HISTORIC LANDMARK COMMISSION
JUNE 24, 2013
APPLICATION FOR A CERTIFICATE OF APPROPRIATENESS
C14H-1981-0017
Burt House
612 W. 22nd Street

Construct a new perimeter fence around the front and sides of the house.

Project: NEW ARCHITECTURAL METAL FENCE & GATE
at
612 West 22nd Street, Austin, TX 78705

PROPOSED GATE DESIGN

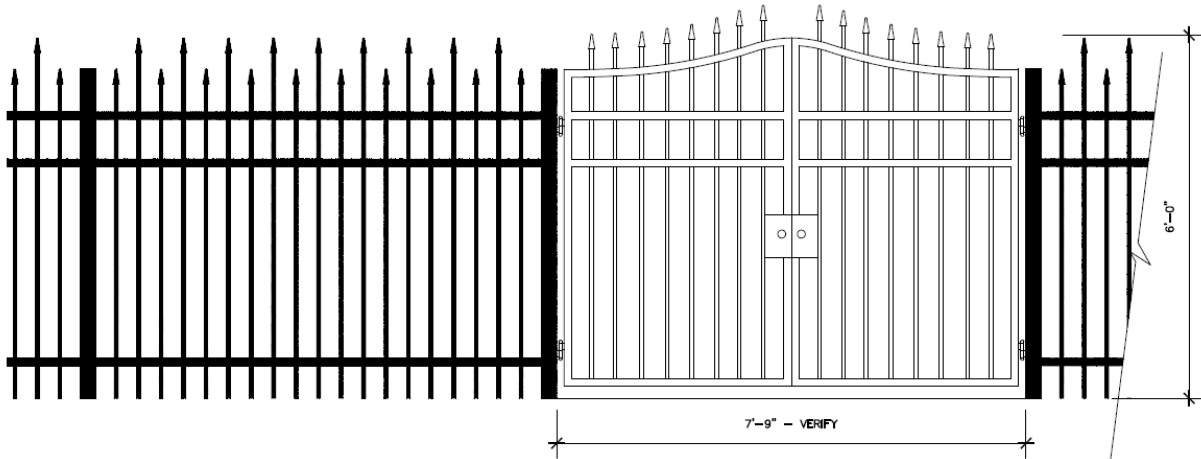
For easy location of the gate to a visitor, it has a curved top panel that would rise approximately 8" higher at the gate middle than the fence. The proposed design of the gate is included at the back of this booklet.
